SERVICE BULLETIN

REFERENCE	BODY
NUMBER	051
DATE	12-21-90
MODEL	SW

FRONT BUMPER COVER CHANGE: WITH FOG LAMPS

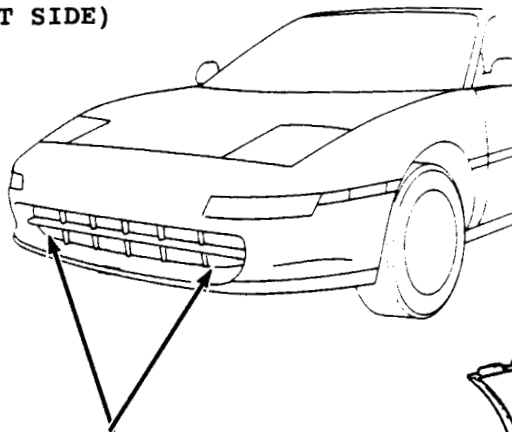
Front bumper cover, Toyota part no. 52119-17904 has been superseded to part no. 52119-17903. Replacement of the bumper cover on vehicles equipped with the fog lamp option will require cutting the new bumper cover to accommodate the fog lamps. Shown below is the procedure for cutting the bumper cover.

Cut the bumper along the embossed line on the inside of the cover, using a knife or saw.
(see diagram)

CAUTION: Be careful not to damage the surrounding areas.
